RE: Revised Plans
Chester River Landing
Chestertown, MD

Re: **Chester River Landing
Stormwater Management Calculations**

SEDIMENT & EROSION CONTROL PLAN
 FOR
CHESTER RIVER LANDING
 TAX MAP 0044, PARCEL 0335, SEVENTH DISTRICT, KENT COUNTY, MARYLAND
 CHESTER RIVER LANDING, LLC.

3-13-07
 2:58:10
 1" = 30'
 PLAN
 05/28/07
SHEET
1 OF 7

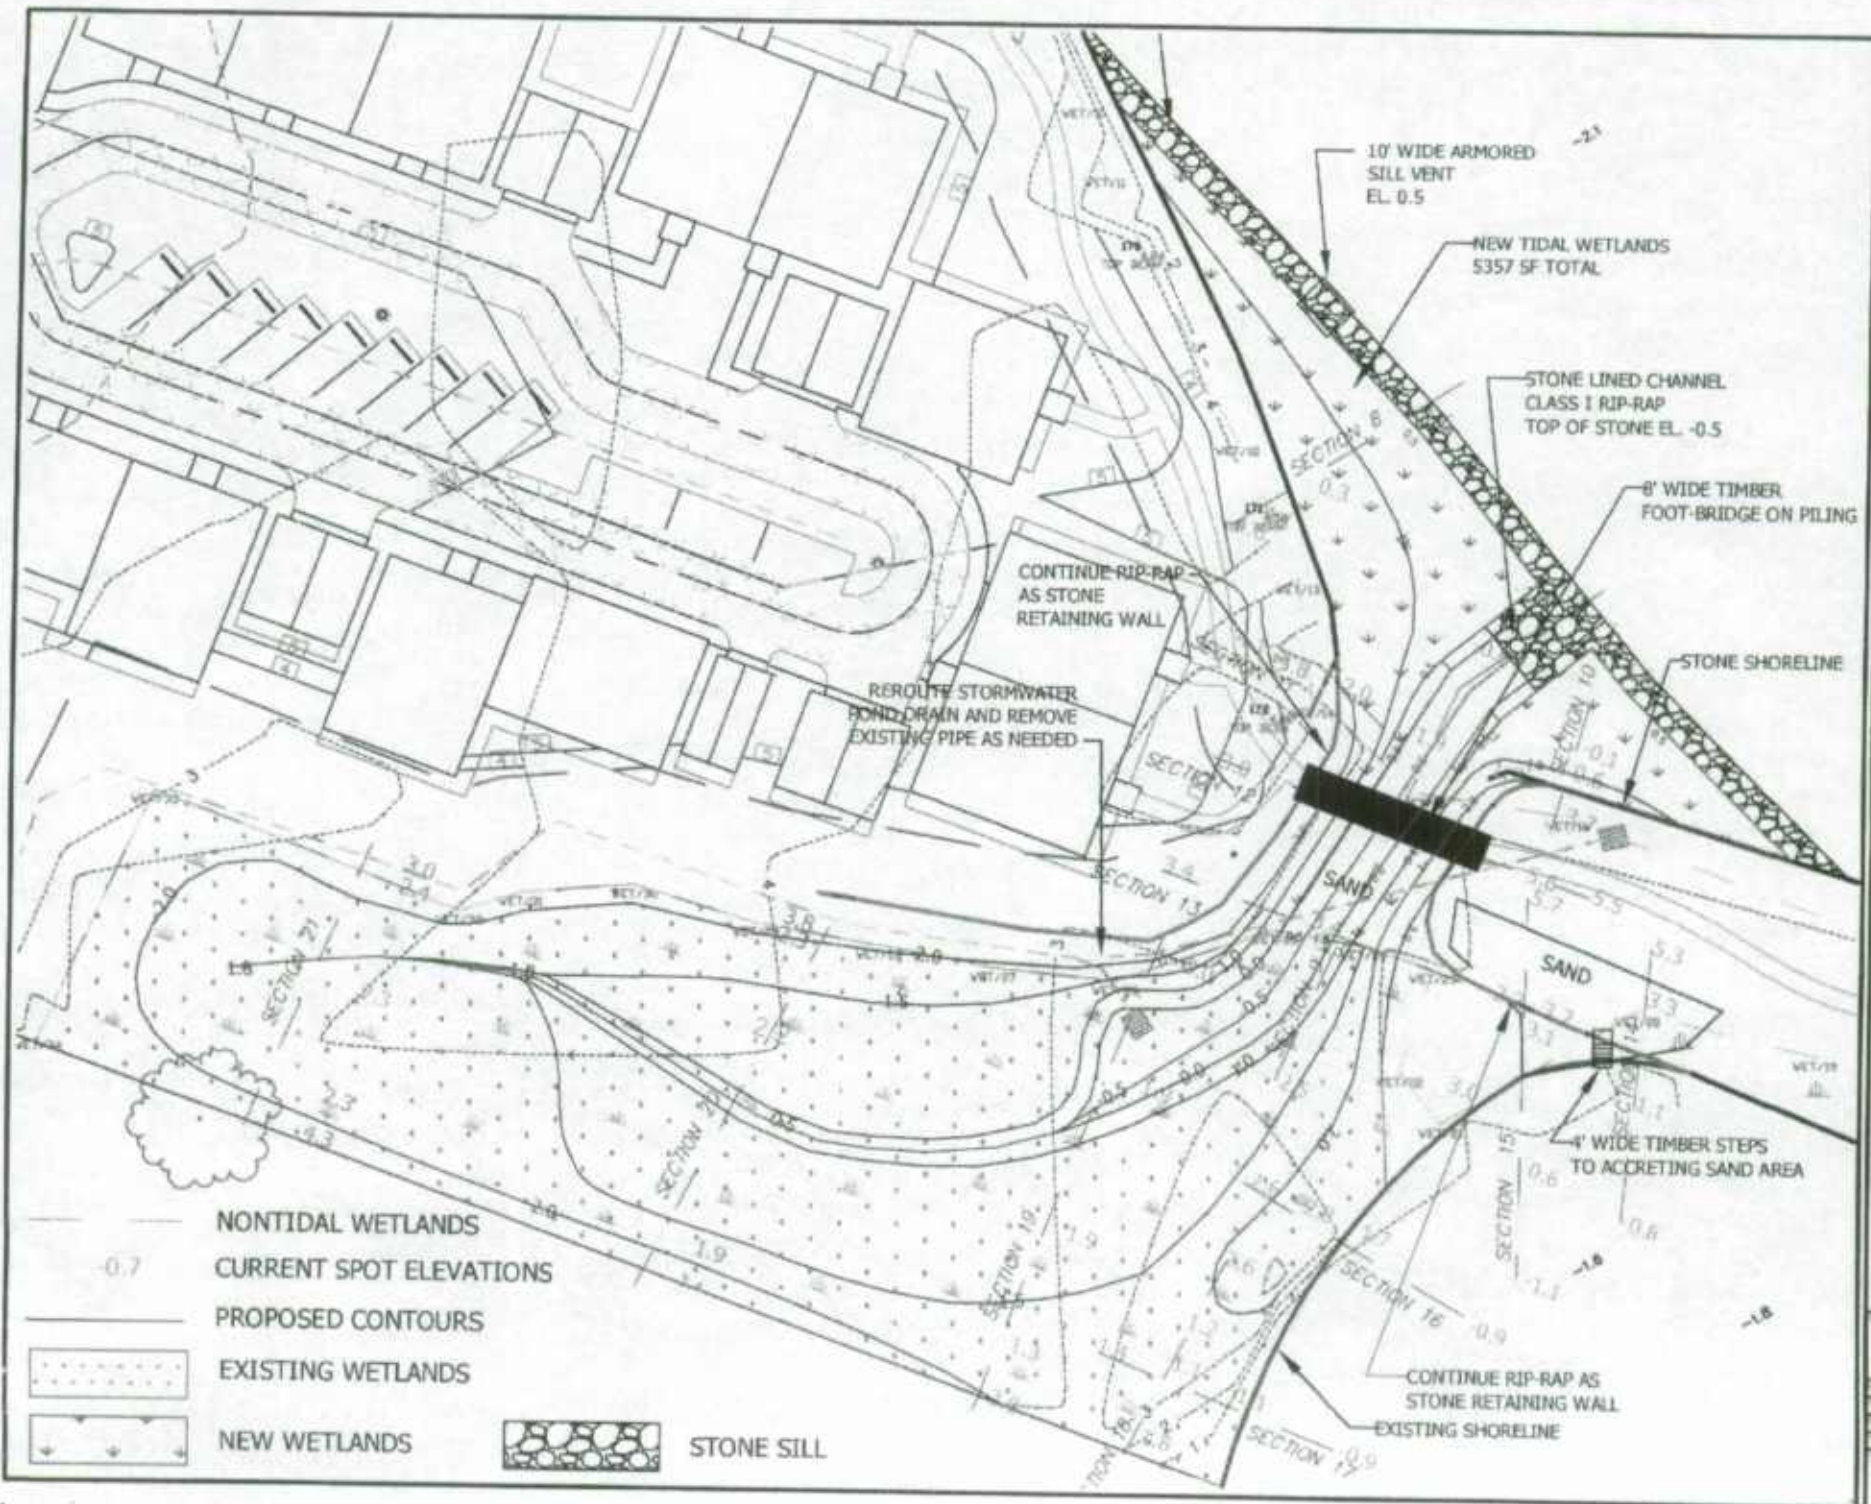
Enclosed are revised plans for the shoreline plantings and tide marsh enhancement at Chester River Landing with the changes requested. I have enclosed full size drawings and 8 ½ x 11 sheets of the actual work areas. These plans include the additional vent requested in the middle sill area, detail of the vents (I also included detail for the new channel opening), and a detail of the stone retaining wall to continue from the shoreline riprap. The latter detail is profile 14. The stone for that particular location may need to be Class II rip-rap to match the existing stone and then change to Class I once it is away from the shoreline.

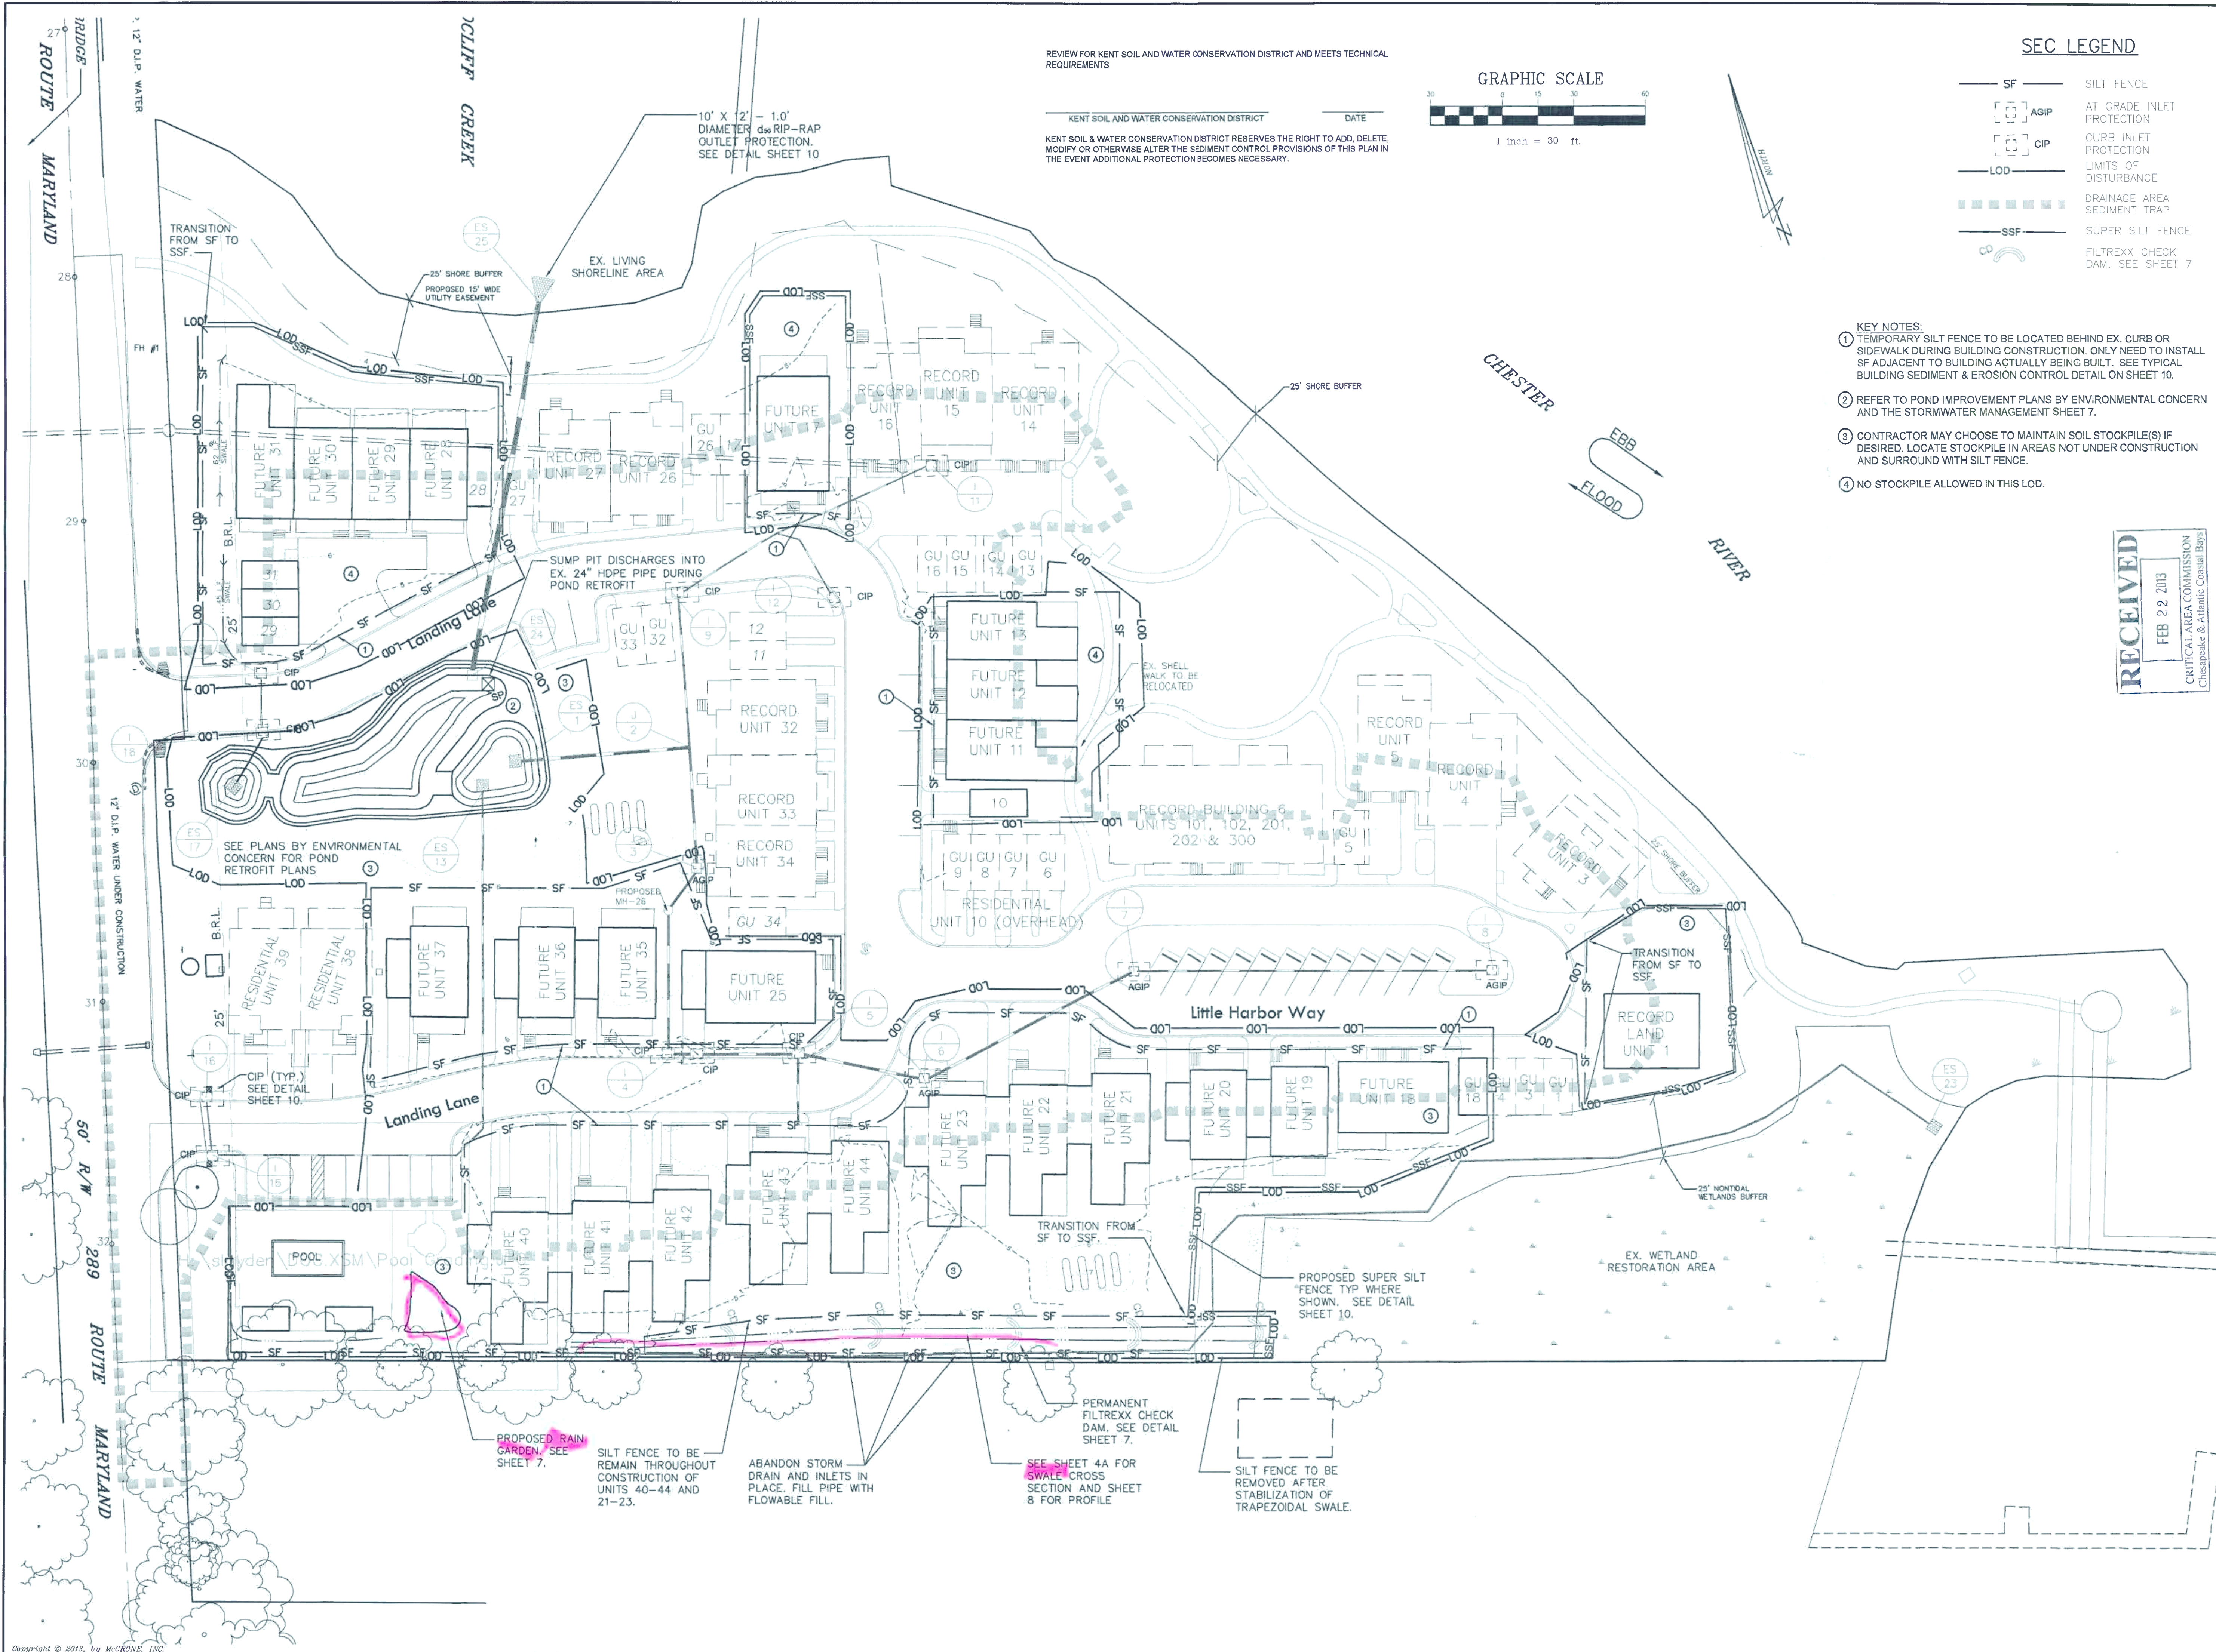
Steve, After analyzing your submittal on the subject we are unable to conduct a thorough review due to mistakes and omissions in the application. While it may be acceptable to use the older 10% Worksheet, it appears generally that you are using a mixture of older and current guidance. A consistent approach would make the review less confusing. In addition we offer the following specific comments:

1. The Buffer cannot be used for rooftop disconnect. Please add the 100 ft. Buffer to all future drainage area maps and recalculate disconnect figures. The Buffer needs to be drawn from current MHW or extent of tidal wetlands, whichever is greater.

2. It does not appear that all of the disconnects draining to the swale meet the distance requirements.
3. A grass swale can only be used for linear projects such as roads. In some of your documents you use the term wet swale. Wet swales are not recommended for residential developments.

4. A reingarden removal efficiency percentage is 50%.
5. It is unlikely that the Critical Area Commission would recommend approval (by the Town) for use of the restored wetland and living shoreline as innovative offset options without substantial documentation. Should you wish to pursue the innovative offset options, the Commission would require all plans and permits associated with the past review of those restorations.

- Per Roby's comment, I am not taking credit for the rooftop disconnection, but did include the disconnection for the perimeter oyster shell paths using the disconnection of non-rooftop runoff credit. Given that the credit limitations require the width of grass to be equal to the width of the path, there is ample pervious area next to the paths and up-gradient of the top of bank along the shoreline. This credit is reflected in a negative proposed area on page one.

- The prior 10% rule calculations were based on impervious surface shown on McCrone's 2003 field survey. We have researched aerial photographs at the Kent County Soil and Water Conservation District (SCWD), as well as looking at Google Earth historical imagery. Both sources show additional improvements existed in 1988 and 1992, as shown on the attached image. It is likely that they or their remnants existed in 2003 and were simply not surveyed—I don't know for sure. It is my understanding that much of the site was an untidy mess when we began work there, and overgrown vegetation may have obscured those features. In any case, we have added additional area for sidewalks/paths and pools, which amount to an additional 0.19 acre of imperviousness. Those areas are shaded in blue on the attached impervious areas exhibit. There appear to be additional areas of impervious that I could count, but I only measured those that were clearly recognizable as impervious.

- We have retained the wet swale in the calculations. While the manual may say that it is not recommended for residential developments, we believe the reason is because the permanent pools they require are not compatible with a residential look and feel. For this swale, we propose Filtrexx check dams: http://www.filtrexx.com/check_dams.htm which are mulch-based and allow filtration of water through the berm. This filtration acts to cleanse the runoff and eliminate permanent pools between rain events. They can be vegetated to blend in with the swale as a whole. Joe Blizzard at the SCWD is prepared to sign off on the device, recognizing the challenges of this site with low elevations and high groundwater. The developer believes the swale will not be a cause for adjacent homeowners.
